# South West Rail Link Glenfield to Leppington rail line

# **South West Rail Link Glenfield to Leppington rail line Environmental Assessment - Submissions and Preferred Project Report**

August, 2010

**Figure 5-1** Extent of works at Edmondson Park Station  
*\*Note: Indicative only, subject to detailed design*

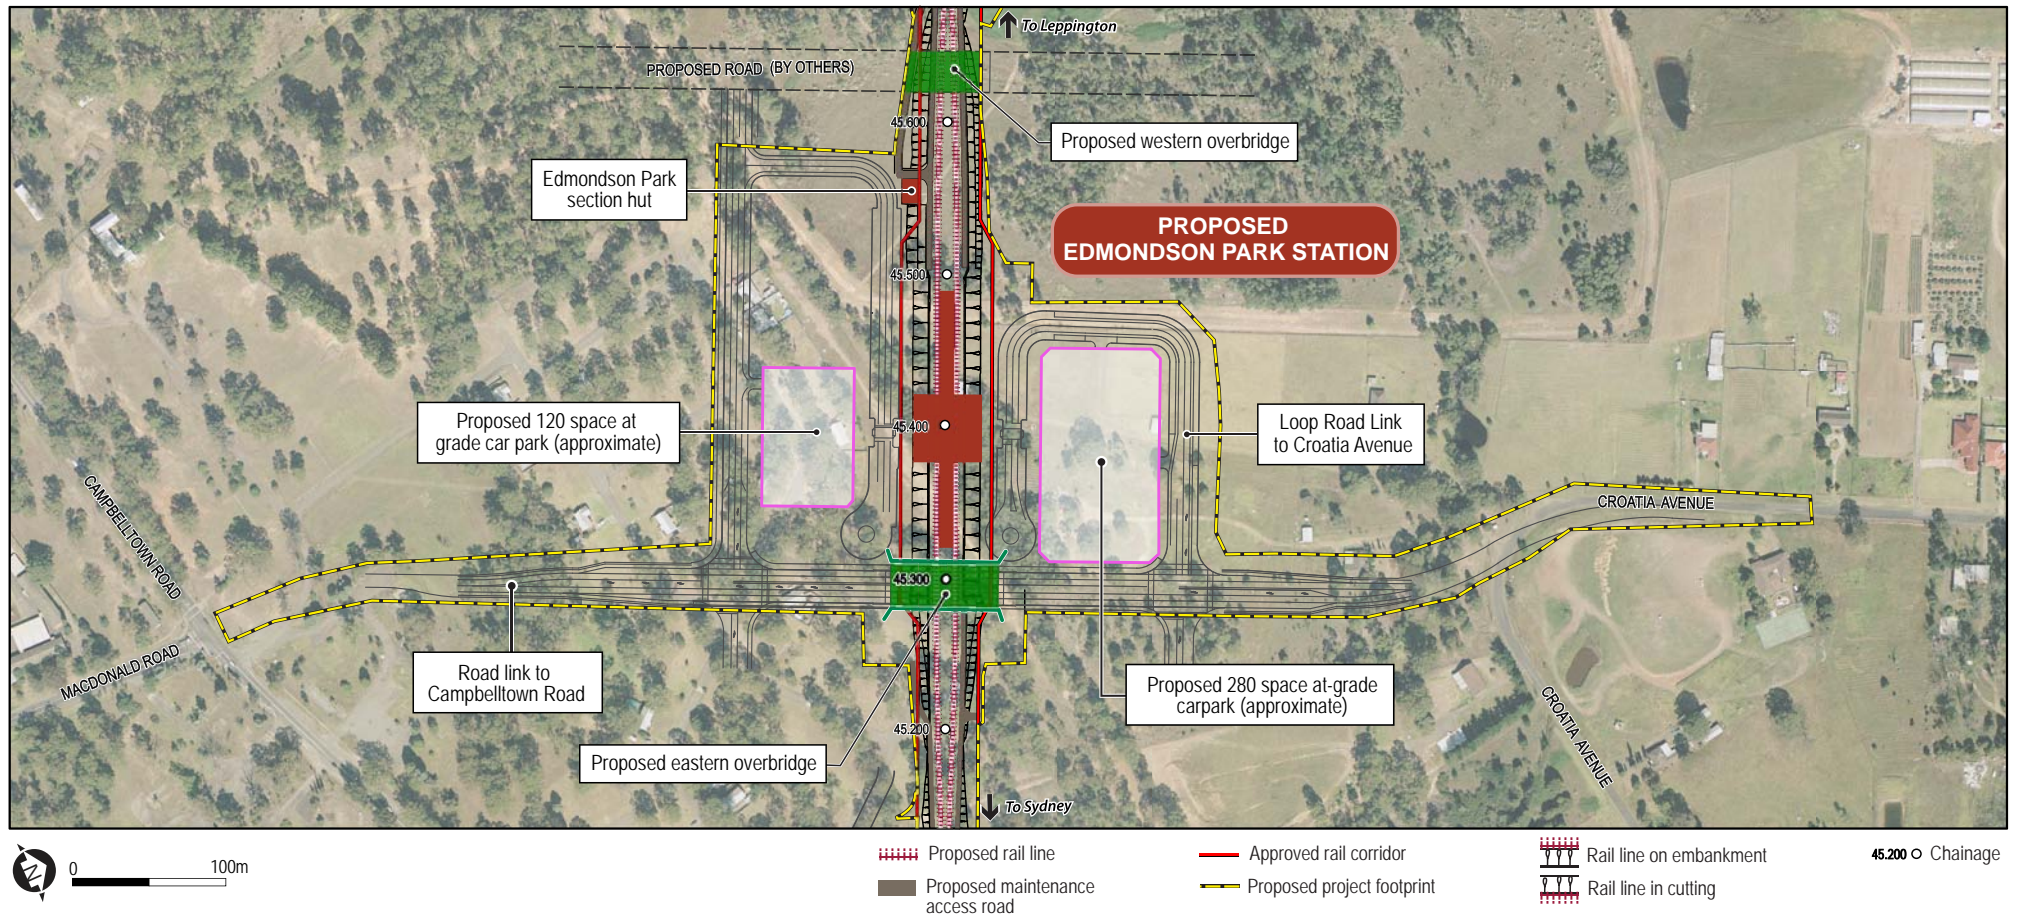
Approval is now sought for the eastern bridge and approach road works and the western bridge (excluding the approach road works). These works were not included in the transport interchange design submitted as part of the EA. Introducing the bridges would necessitate raising the levels of some roads to match the bridge levels. Figure 5-1 identifies the proposed changes to the Edmondson Park interchange.

**Figure 5-2 Preferred Option — potential additional landscape planting**

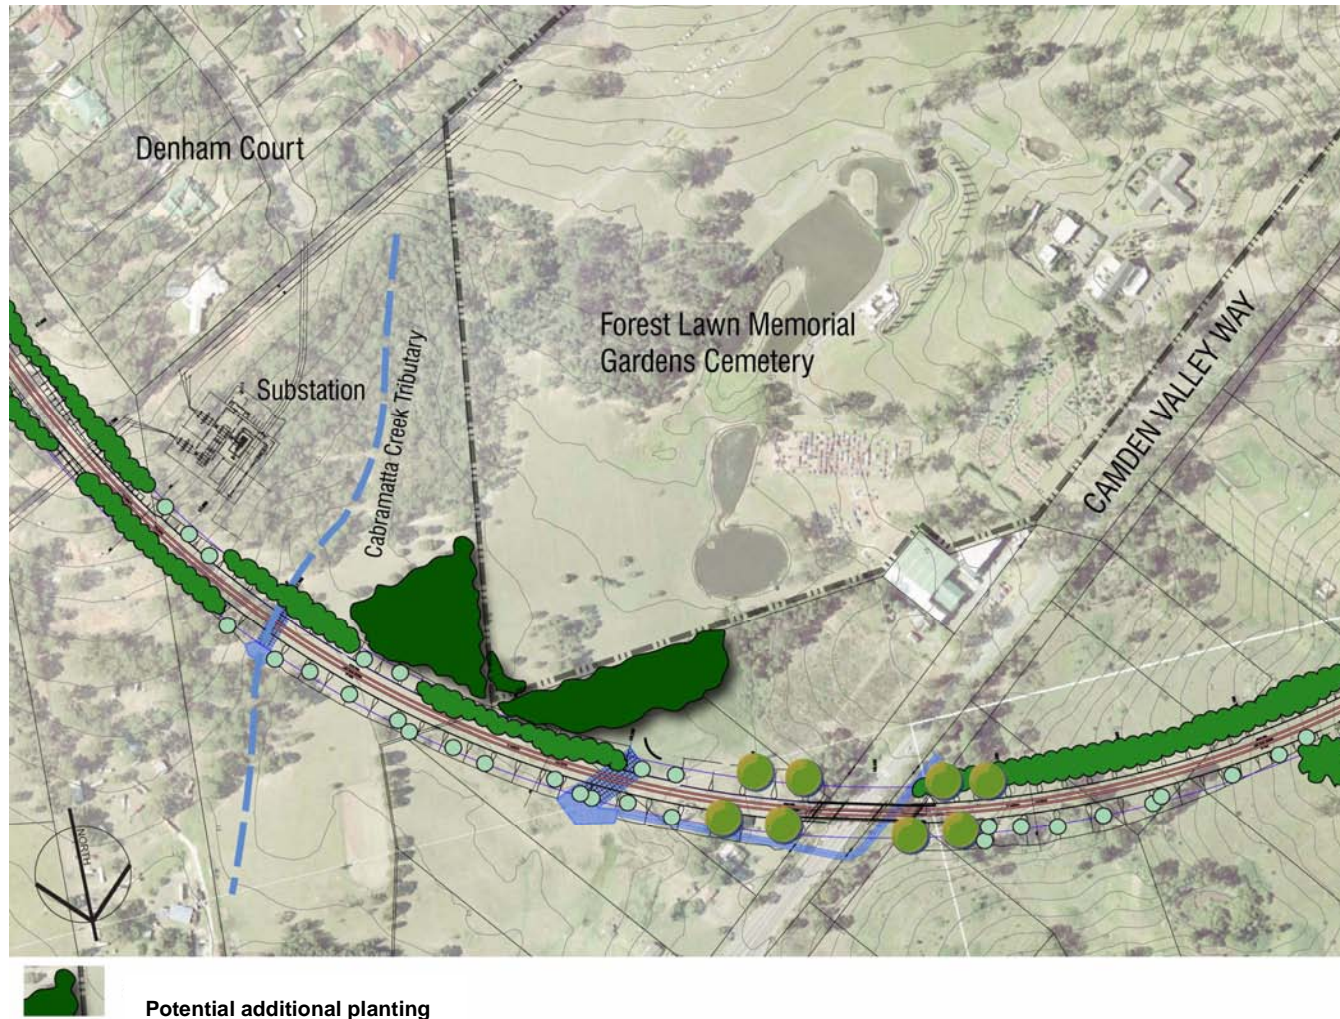
Residual land between the cemetery and the rail line, currently in the DoP ownership, could be utilised for landscape planting (refer to Figure 5-2). Planting within this area could commence immediately so that plantings would have time to establish prior to operation of the SWRL.

Following the options evaluation, the preferred visual impact mitigation option for Forest Lawn Memorial Gardens is Option 4 (see Section 6.8.1). This includes the currently proposed noise wall within the rail corridor and an increase in landscaping relative to that proposed in the EA (refer to Section 6.8.1 and Figure 5-2). The proposed landscaping within the Memorial Gardens would be the responsibility of Invocare, in accordance with their revegetation requirements. A detailed landscape plan for this area would be provided prior to any construction works, as detailed in SoC No. 66.

**Figure 5-4** Extent of works at Leppington Station  
*\*Note: Indicative only, subject to detailed design*

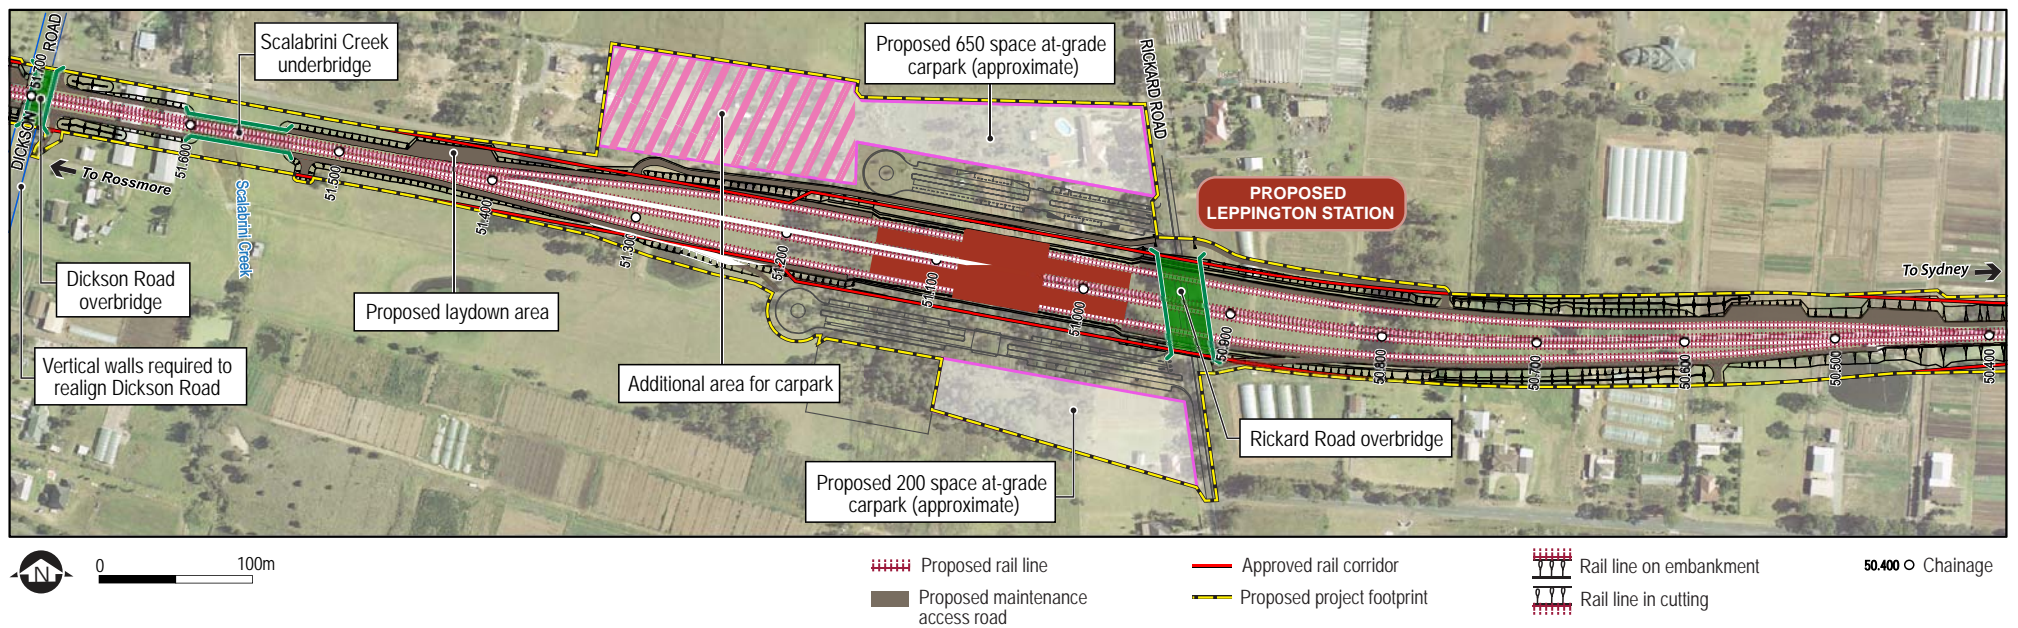
The land identified for additional car parking is adjacent to the proposed transport interchange on the northern side of the station and is approximately 300 metres at its furthest point from the northern entrance to Leppington Station (see Figure 5-4). A number of options were considered for the location of the additional commuter car parking area, including sites both north and south of the station. The site chosen was selected because:

Figure 5-5 Additional construction and compound sites

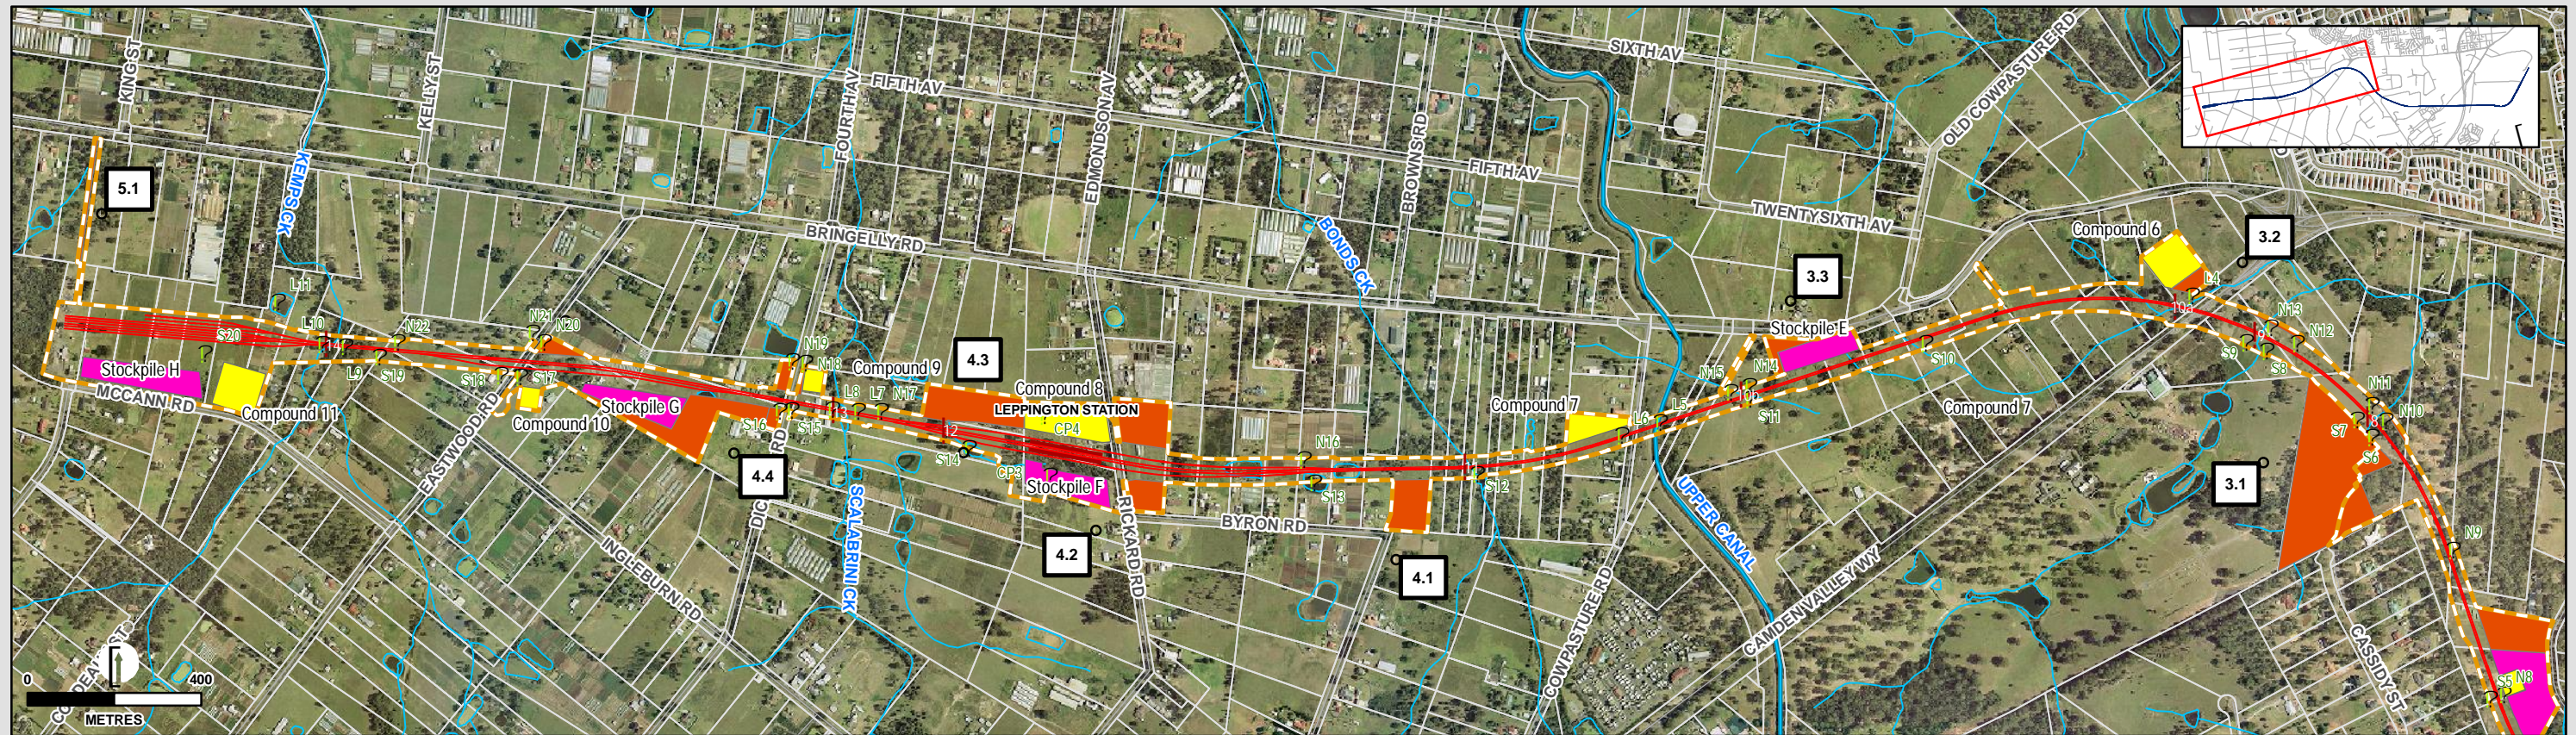
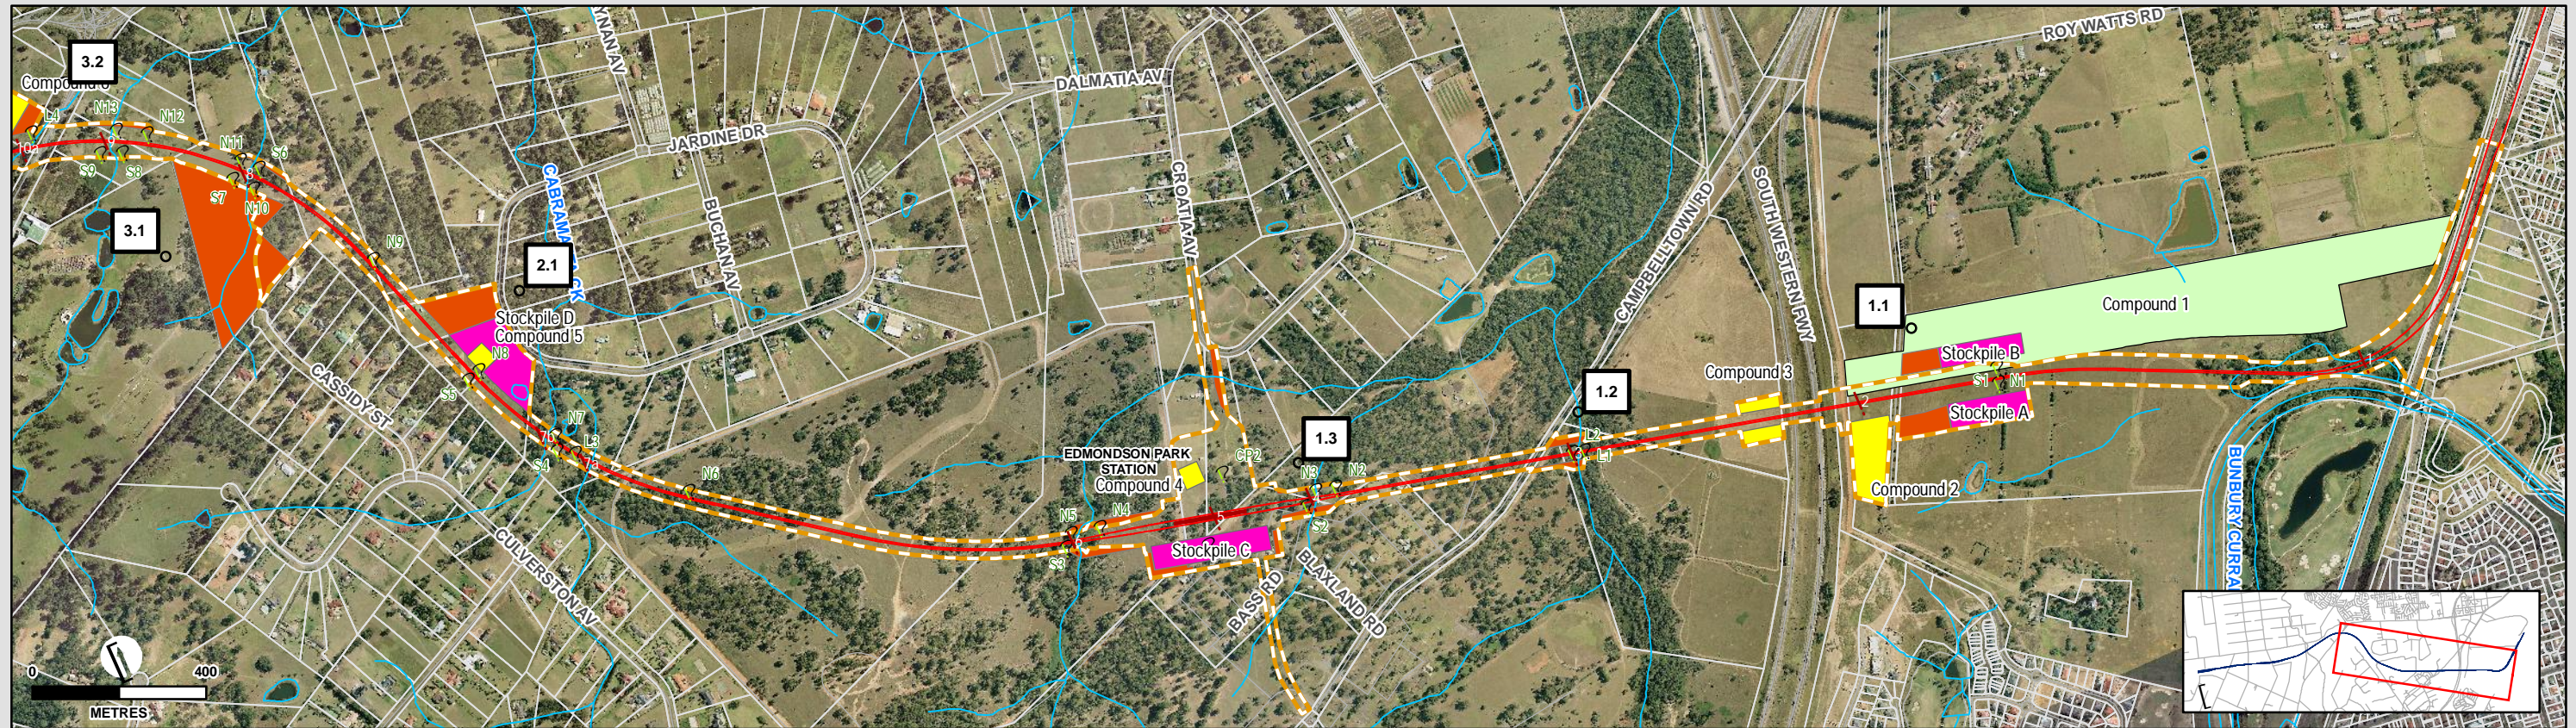
In May 2010, TCA identified an additional 13 sites potentially required for construction and operation of the project (refer to Figure 5-5). These potential additional sites are a result of design development since the exhibition of the EA. The 13 sites include areas for improved construction access, three new construction compounds/worksites, amendments to two previously proposed construction compounds, new stockpile locations, maintenance access to culverts, relocation of the Integral Energy substation, and additional commuter car parking at Leppington (refer to Figure 5-5 and Table 5-1).

As part of the ongoing design development and review for the project, TCA has reassessed the potential construction compounds identified in the EA. This review determined that construction compound No. 3 (as shown on Figure 5-5) is no longer required for the construction of the project and should be removed from the clearing footprint. That is, the likely construction compound requirements would be satisfied by the remaining construction compounds proposed.

**Figure 6-9 Section: Proposed substation planting**

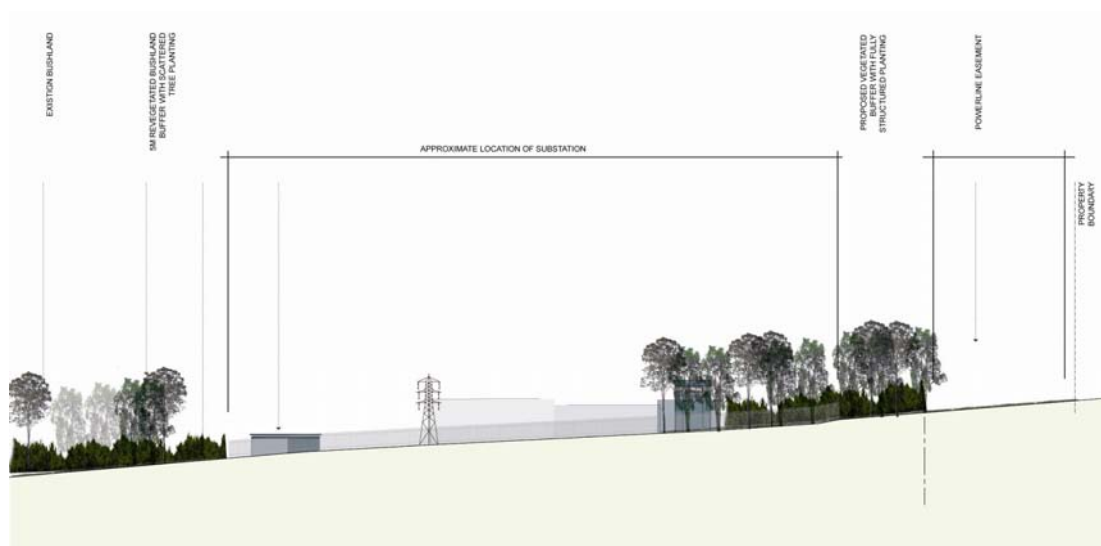
The location of the substation within a dense stand of existing vegetation would provide initial screening and reduce its potential visual impact. This, combined with planting of additional vegetation along the southern boundary of the substation, would create a substantial visual buffer (Refer to Figure 6-8 and 6-9). The location of the access road to the north of the easement would allow a portion of woodland to remain between the easement and the road, which would provide adequate screening between the substation and the closest residence. The access road and low level use by Integral Energy employees would
